# PLANNING AND ZONING CASE CHECKLIST City of Rockwall Planning and Zoning Department 385 S. Goliad Street Rockwall, Texas 75087

SP2019-030

**Project Name** 1480 Justin Road SITE PLAN

SP2019-030; Amended Site Plan for SPR Packaging

08/14/19

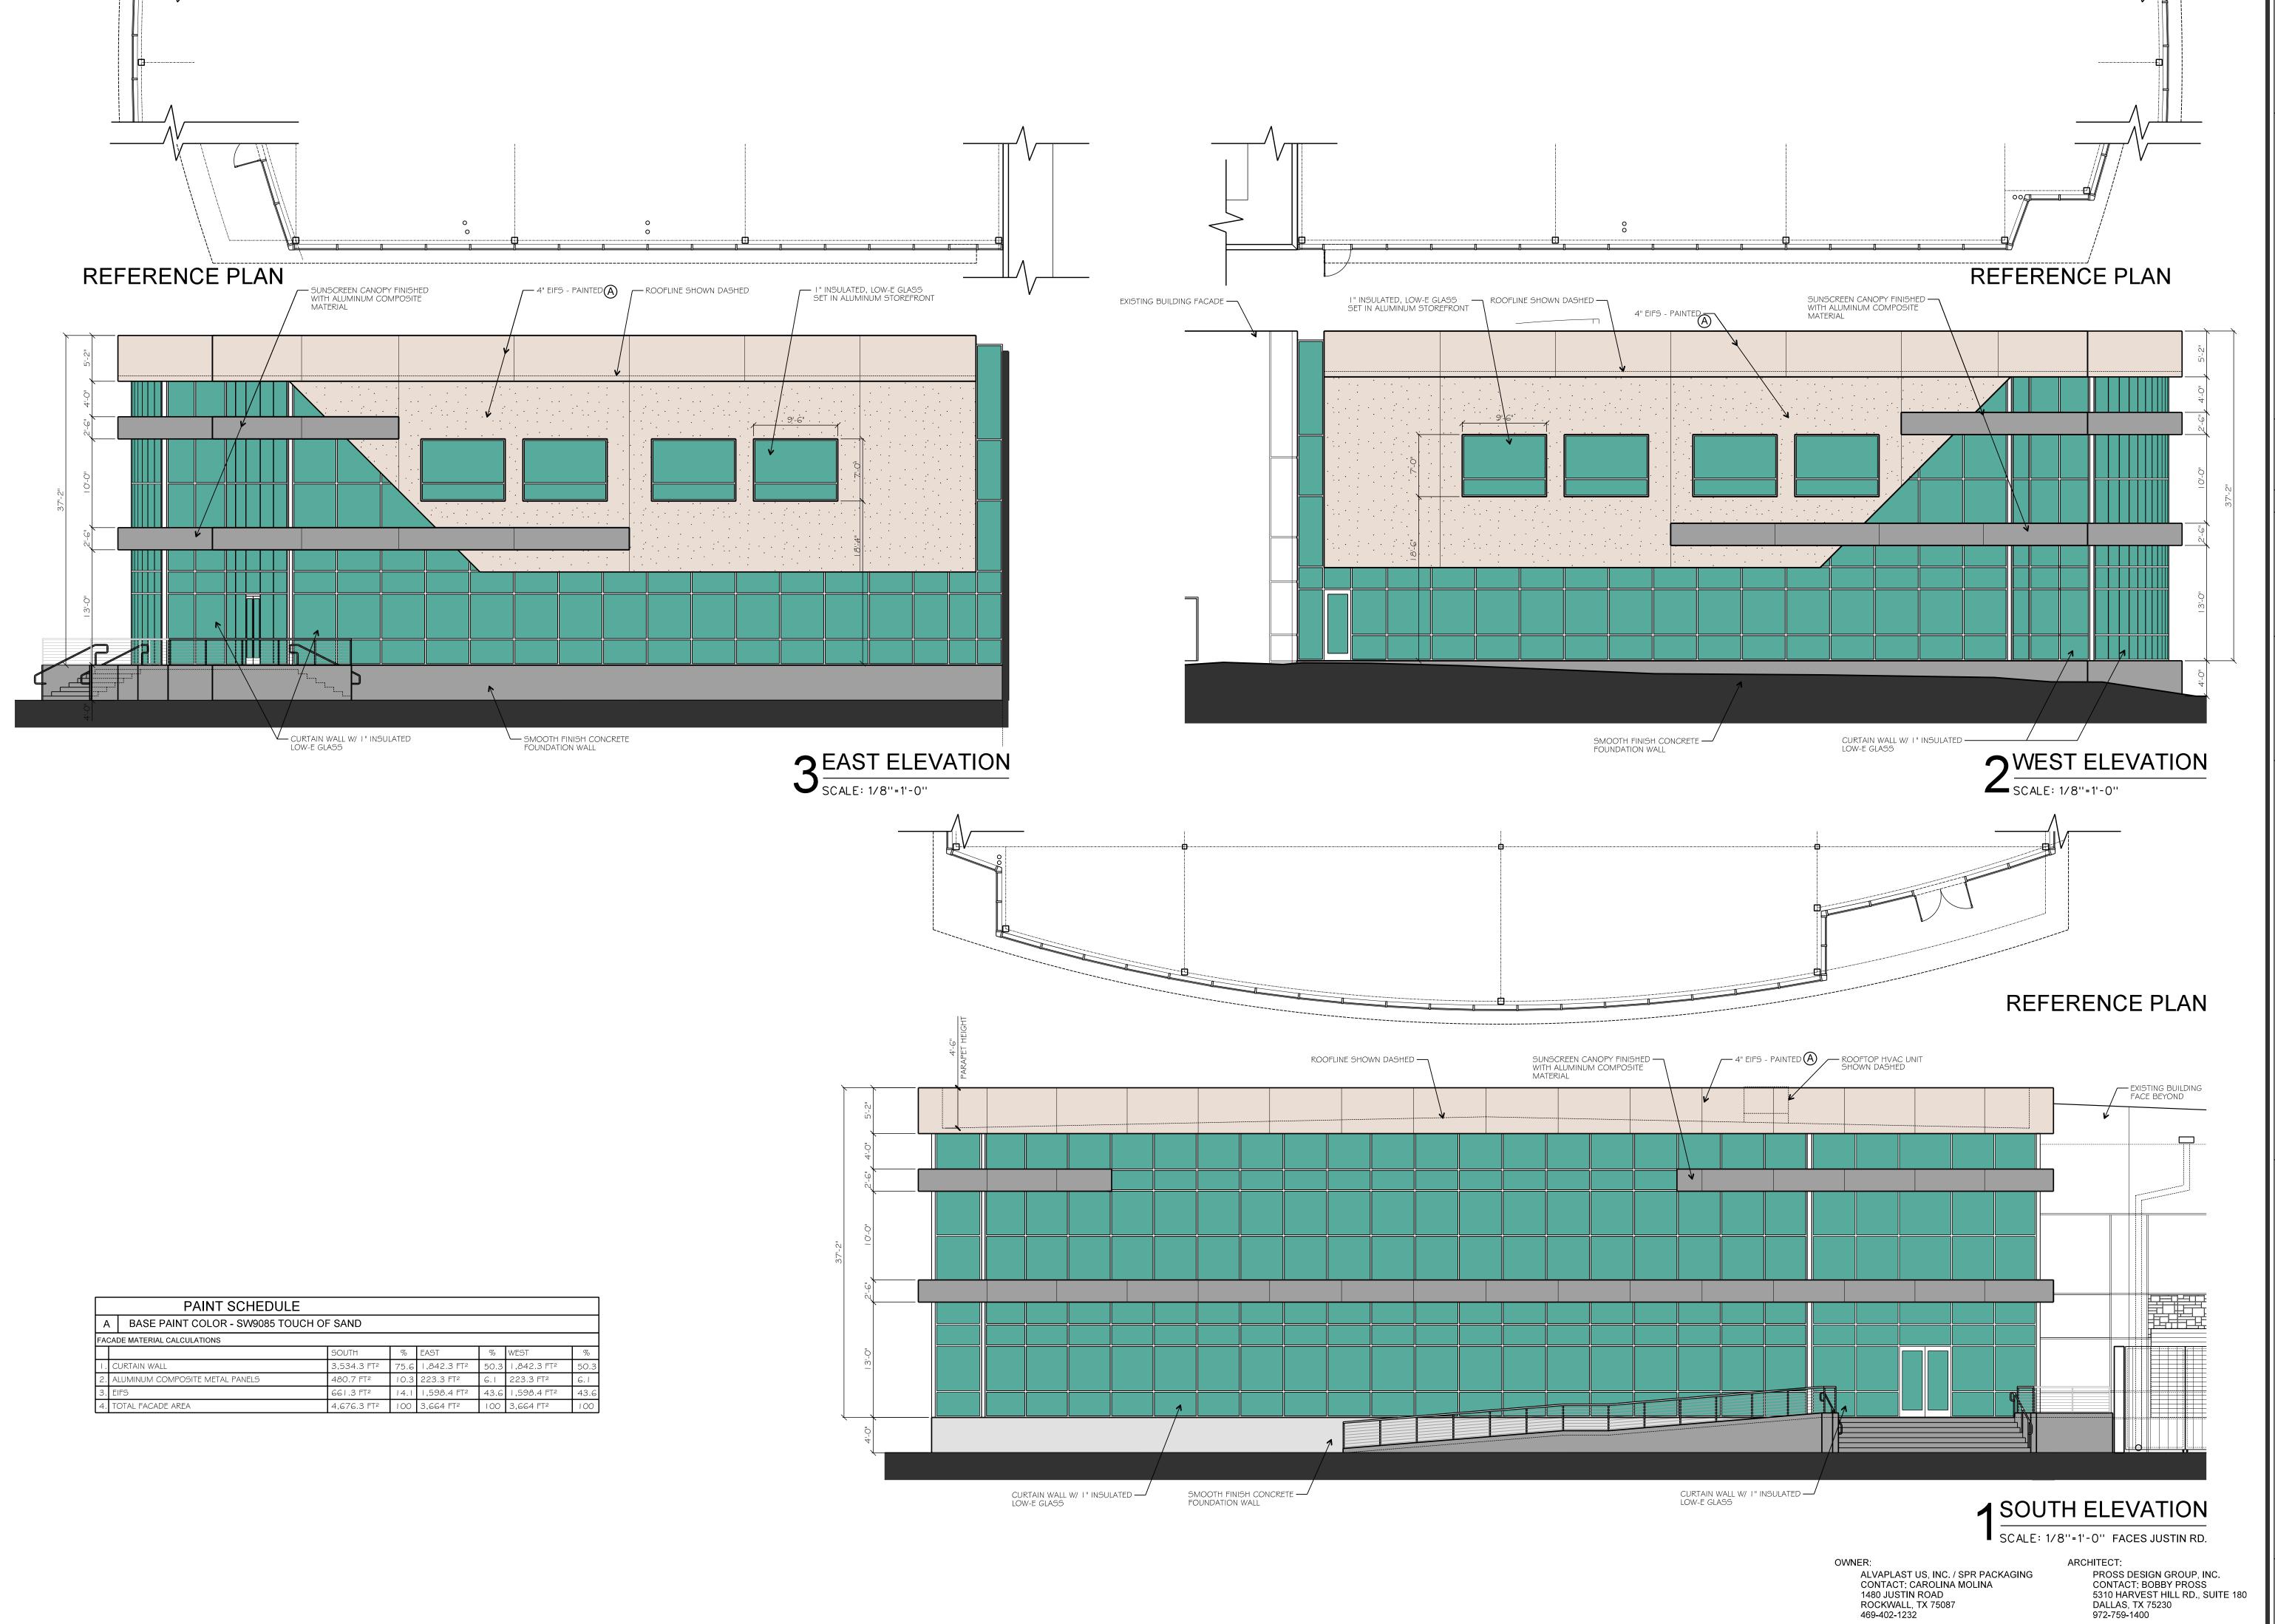
- M.8 Building Elevations. According to Subsection 5.02, of the General Industrial District Standards, of Article V, District Development Standards, of the UDC, requires a minimum of 20% stone (i.e. natural or synthetic/cultured) on all building façades. In this case, the construction of the addition does not include stone on any façade. This will require a variance from the Planning and Zoning Commission pending a recommendation from the Architectural Review Board(ARB).

- M.10 Building Elevations. Please review the articulation formulas contained in Section 5.01.C of Article V, District Development Standards, of the UDC. The submitted building elevations do not appear to meet all the formulas required for building articulation. This will require a variance from the Planning and Zoning Commission pending a recommendation from the Architectural Review Board (ARB).

- 2) Please provide a detail for the EIFS, the plan indicates "4" EFIS". Is this stucco?
- M.12 Landscape Plan. Please make the following clarifications and changes to the landscape plan to ensure staff can properly review this project and convey all of the required elements to the City's boards and commissions:
